Questions	Responses
1.	Demo area says refer to asbestos report??? Not part of this package we have located acm survey dated 11.19.21 are we to use this as the basis for the ACM removal proposal? a. ACM removal sub has requested site access to physically inspect the premisesplease provide a date and time for this visit	Asbestos report posted @ https://www.cfcecares.org/procurements, procurements page. CFCE will post on website date and time for the subs to visit the site.

Aluminum Service Poles

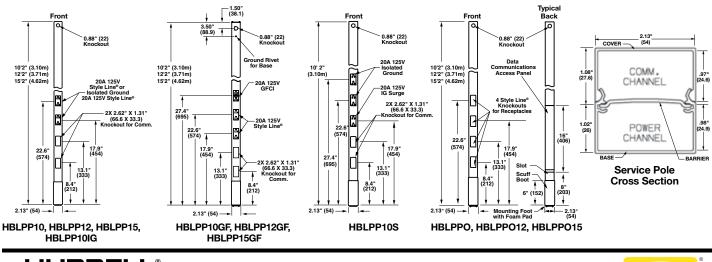
23.	Power poles in cube areas noted as 220v all new outlets noted as 120v where are 220v outlets? What is power pole spec?	All new receptacles and outlets 120v. See attached power pole spec or equal.
